1. Type of Well ☐ ☐ Gas Well ☐ ☐ Other			
	8. Well Name and No. FEDERAL 23 #3		
2. Name of Operator RIDGEWAY ARIZONA OIL CROP	9. API Well No.		
3a. Address 777 N. ELDRIDGE PRKWY #150, HOUSTON, TX 77079 3b. Phone 832-48	30-041-10529 10. Field and Pool, or Exploratory Area

Plugging Procedure Federal 23 #3 API No. 30-041-10529 O-23-07S-33E 660 FSL 1980 FEL

Federal 23 3 30-041-10529 Ridgeway Arizona Oil Corp May 16, 2016 Conditions of Approval

Lease	NMNM83197	
Well Name	Federal 23	Well No. 3
Field County State	Chaveroo	4 7 7 7
County	Roosevelt	4 12
State	NM	
Date	5/3/2016	
Date Comp		
KB	0.00	34-7

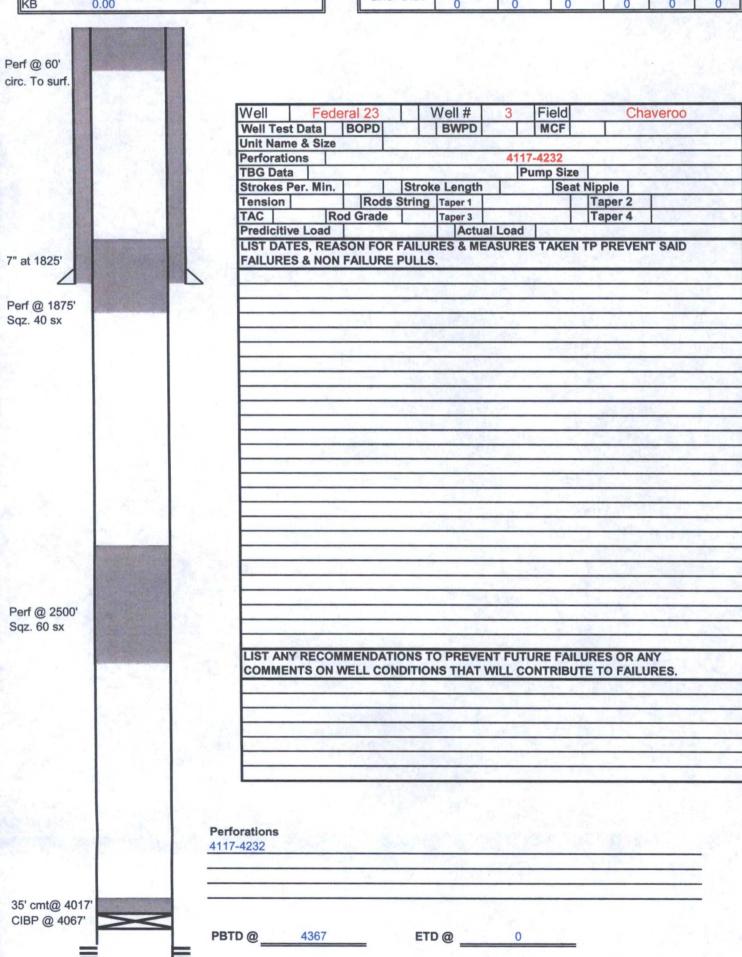
- 1. Operator shall place CIBP at 4,067' (50'-100' above top most perf) and place 35' of Class C cement on top as proposed. WOC and TAG.
- 2. Operator shall perf and squeeze at 2,500'as proposed tagging plug at 2,300'.
- 3. Operator shall place a balanced Class C cement plug from 2,300'-2,150' to seal the top of the Yates formation. WOC and TAG.
- 4. Operator shall perf and squeeze at 1,875' as proposed tagging plug at 1,775' to seal the surface shoe.
- 5. Operator shall place a balanced Class C cement plug from 60'- surface as proposed
- 6. See Attached for general plugging stipulations.
